NUMBER: 02-002-13

GROUP: Front Suspension

Cold Weather Noise From Front End Over Bumps

2012- 2013 (FF) Fiat 500

Fig. 1 Strut Disassembly

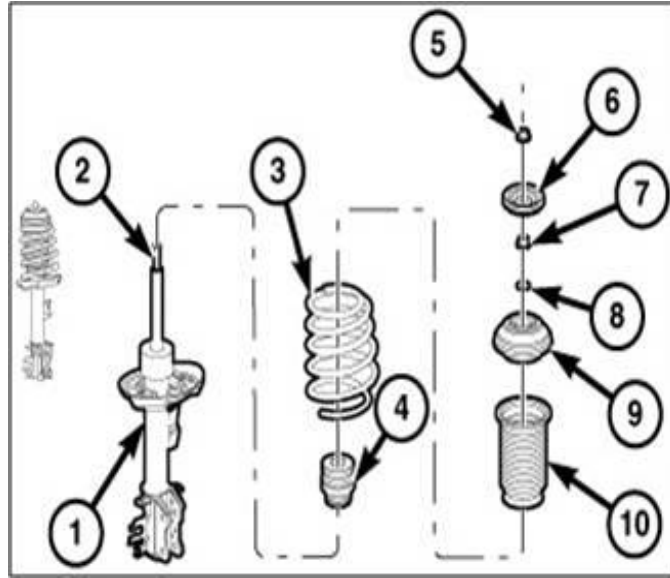
This bulletin involves replacing both left and right front jounce bumpers.

The customer may experience a noise from the front of the vehicle while going over bumps which may be more noticeable in colder temperatures.

1. Remove and disassemble the left and right front strut assemblies. Refer to the detailed removal procedures available in DealerConnect>TechCONNECT> under: Service Info> 02 - Front Suspension> Front> STRUT, Suspension, Assembly> Removal/Disassembly.
2. Replace both left and right front jounce bumpers (4) ([Fig. 1](#)).
